Town and Country Planning Act 1990  
Appeal by SIW Properties  
Site Address: Land west of Highfield, Sled Gates, Fylingthorpe, North Yorkshire,  
YO22 4TZ

## **Comments on issues in the Appeal Documents for Appeal Reference APP/W9500/W/22/3301450**

**Land west of Highfield, Sledgates, Fylingthorpe, North Yorkshire**

**By Dr Timothy Reed BA, MA, DPhil, C. Biol, FCIEEM**

Figure 1. Approximate locations of ATC01 (NE splay) and ATC02 (SW splay) for illustrative purposes only.

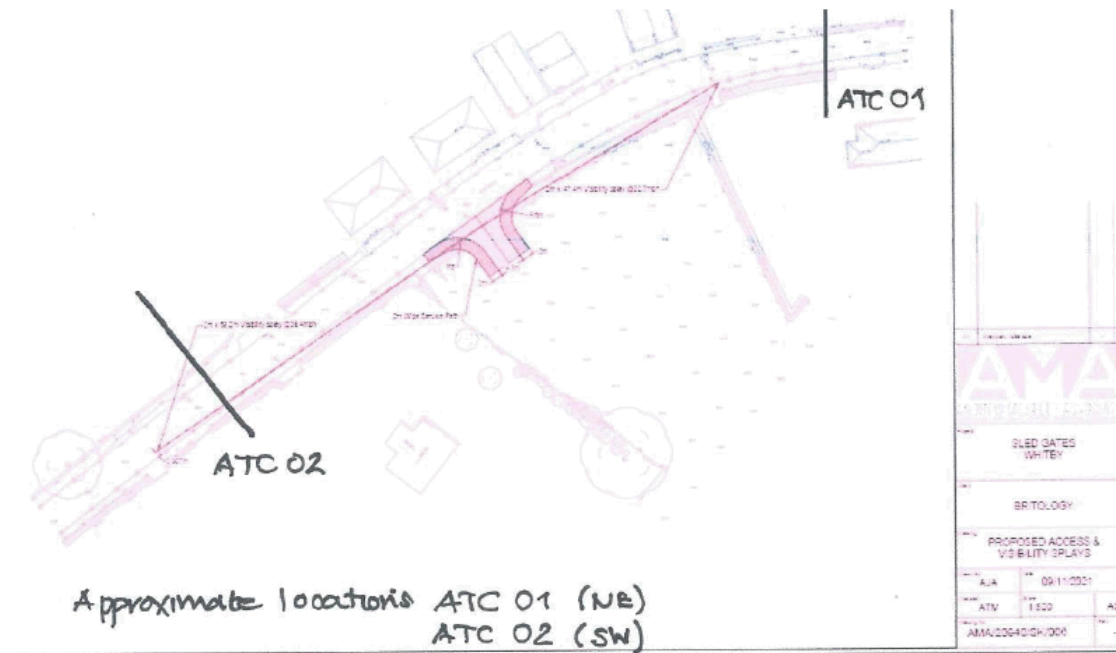
In para 3, AMA **reversed** the directions by mistake. It was **westbound** (uphill) traffic recorded at ATC01 that had 85<sup>th</sup> percentile speeds of 32.7 mph/ 52.53 kph. It was **eastbound** (downhill) traffic that had 85<sup>th</sup> percentile speeds of 38.4 mph / 61.8 kph. For clarity, the rough location of each is shown in Figure 1 below:

In para 3 quoted above, it is clear that the majority of cars going up and downhill were speeding in both directions. It may help to show the scale of speeding, using the Appellant’s data set.

Table 1 shows the traffic at ATC01. This is the lower of the two sites (to the NE of the site), and the nearside traffic is going uphill. Table 1 covers the period 1-7.10.2021. Note that the location of ATC01 was well within a 30mph zone and approached from the heart of the village up a hill.

At a point c 70m below the planned egress point for the proposed development, coming from within a 30mph zone, **well over 600 cars were speeding >30 mph** around a corner approaching the entrance. Note that cars are normally parked (Fig 2) on the other side of the road, making this a dangerous pinch point. **Speeding cars passing both ways were in excess of 1000 during that week.**
